SUBJECT: Forwards response to Generic Ltr 83-28, Section 4.3 re design package for DB-50 reactor trip switchgear automatic reactor protection sys trip via switchgear shunt coil trip attachment.

Docket 50-305
Operating License DPR-43
Kewaunee Nuclear Power Plant
Generic Implication of Salem ATWS Event (Generic Letter 83-28)

DB-50 REACTOR TRIP SWITCHGEAR
AUTOMATIC REACTOR PROTECTION
SYSTEM TRIP VIA THE SWITCHGEAR
SHUNT COIL TRIP ATTACHMENT

WISCONSIN PUBLIC SERVICE CORPORATION
KEWAUNEE NUCLEAR POWER PLANT

FIGURE 1 of 3

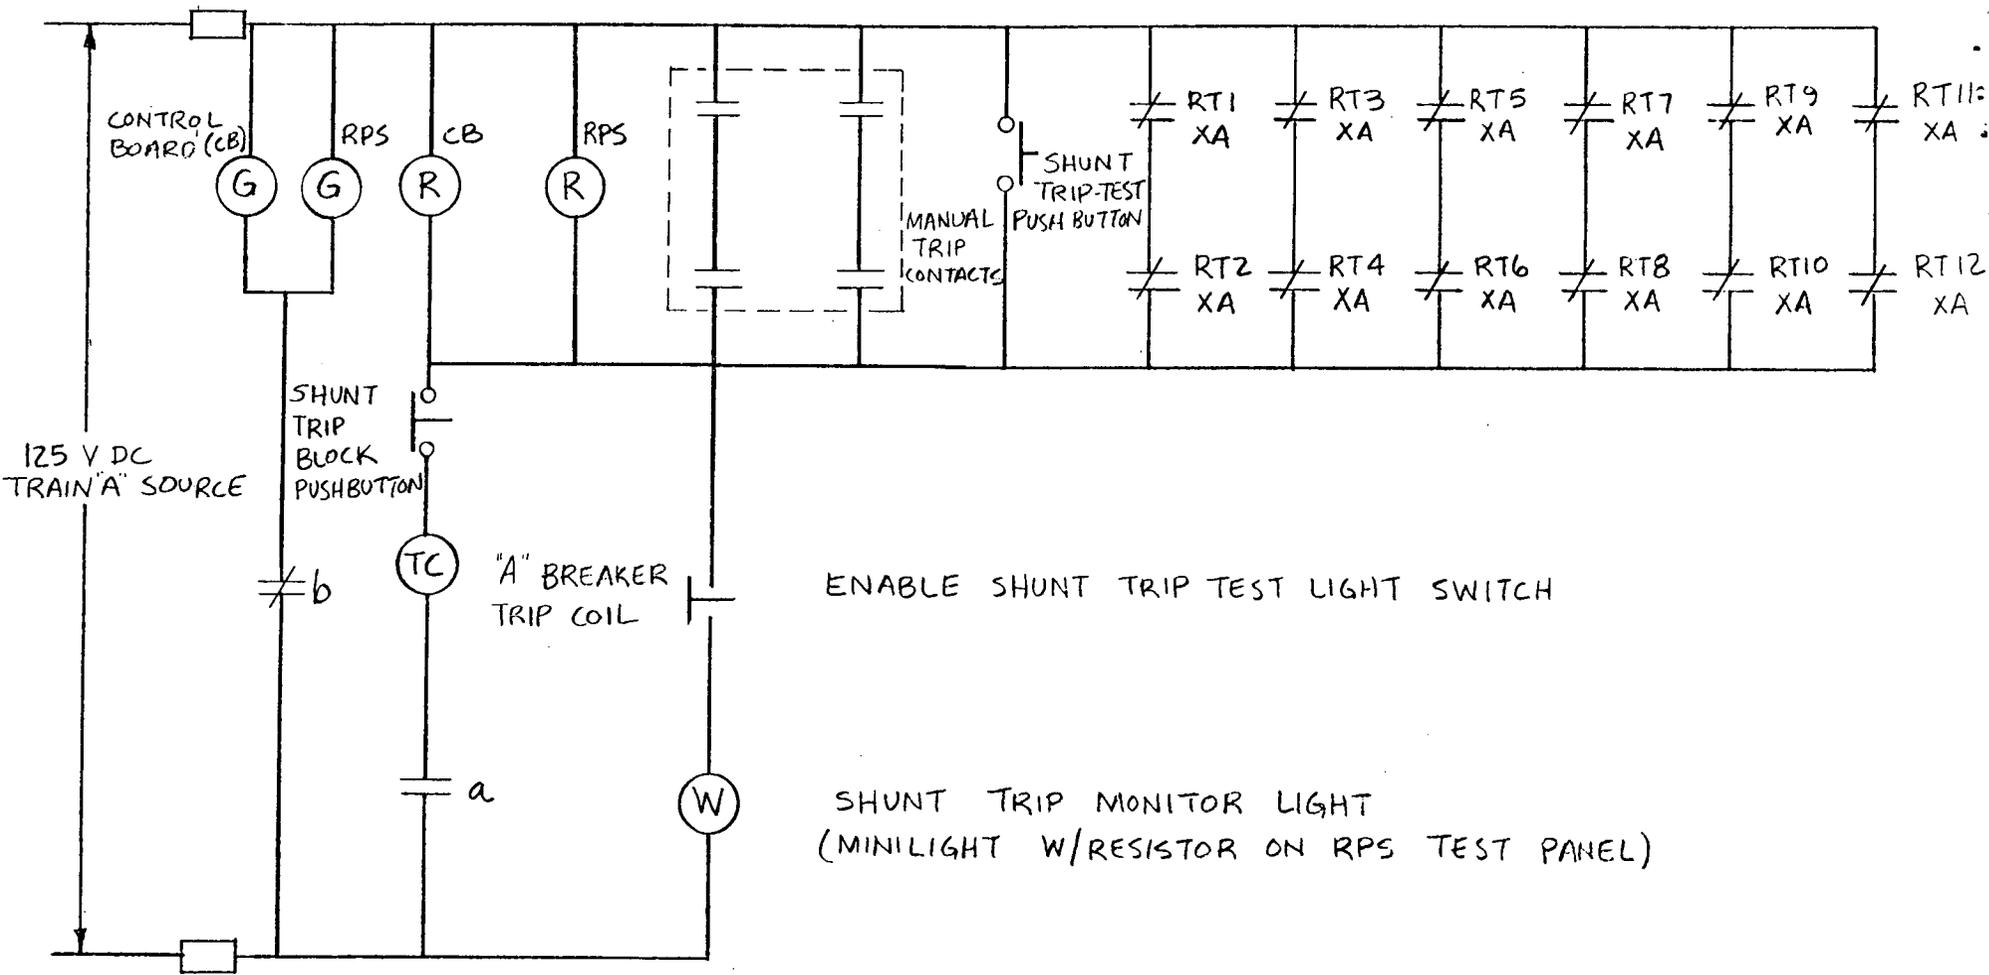
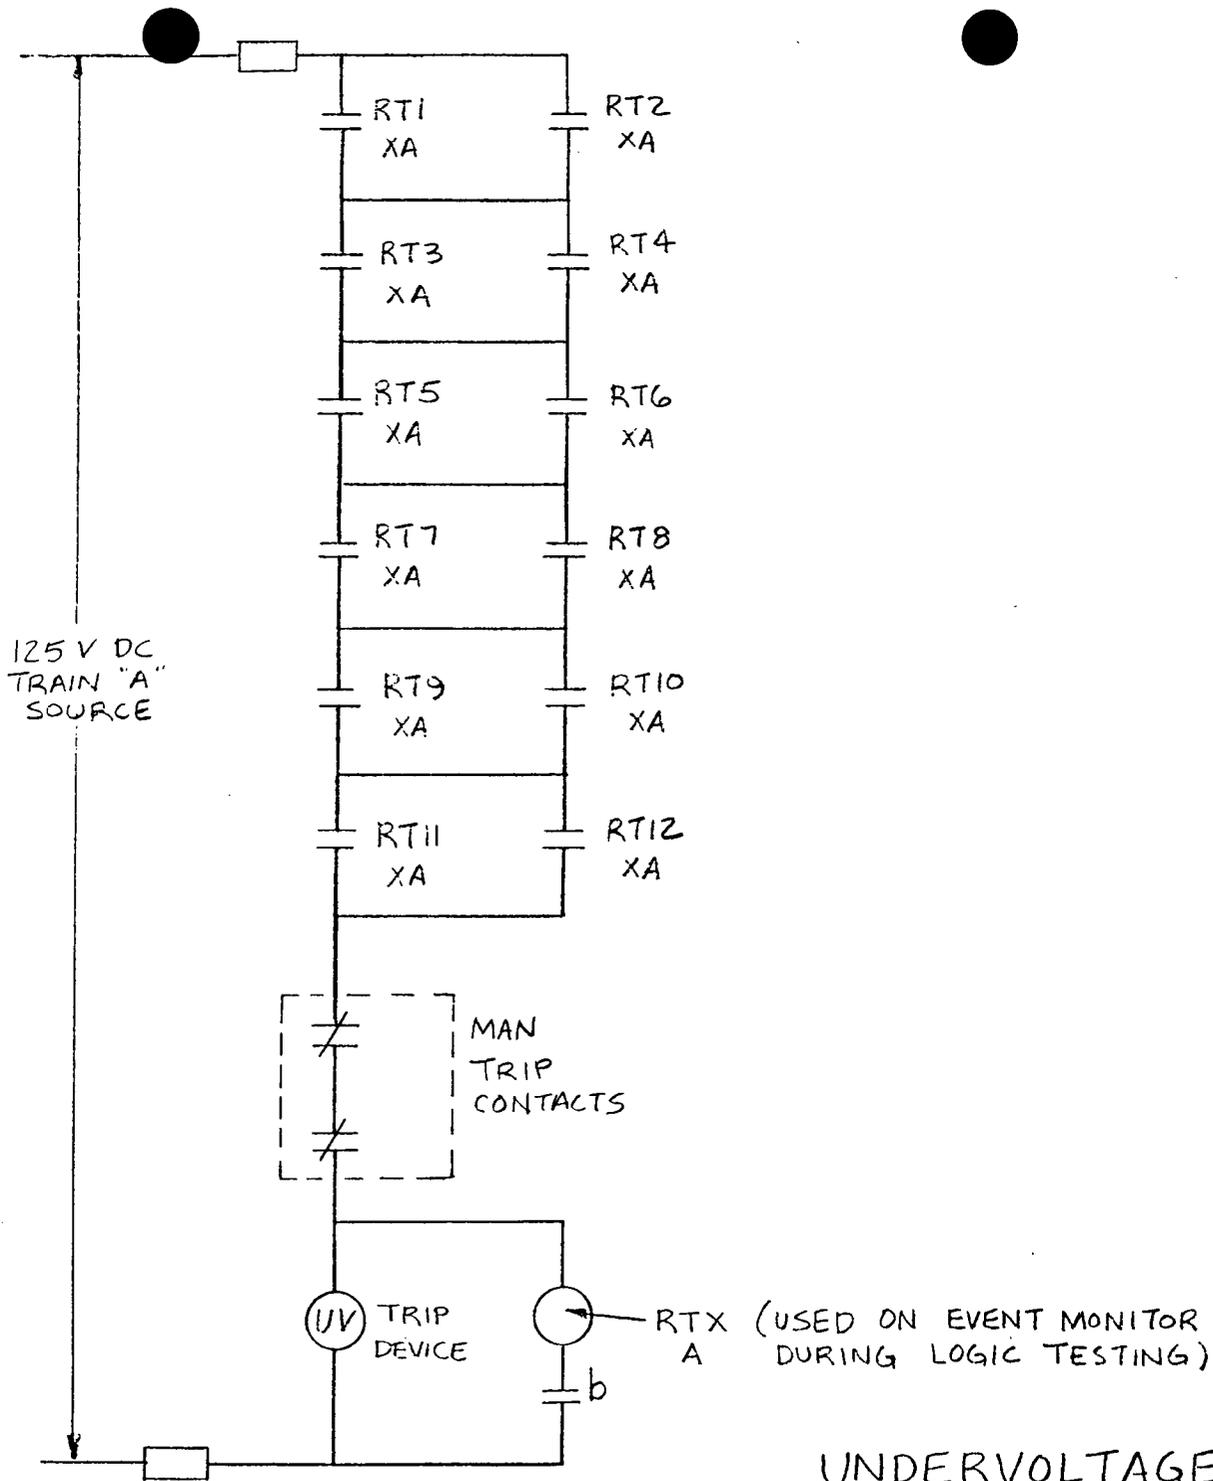
Provide the electrical schematic/elementary diagrams for the reactor trip and bypass breakers showing the undervoltage and shunt coil actuation circuits as well as the breaker control (e.g., closing) circuits, and circuits providing breaker status information/alarms to the control room.

The attached three figures show the proposed modification.
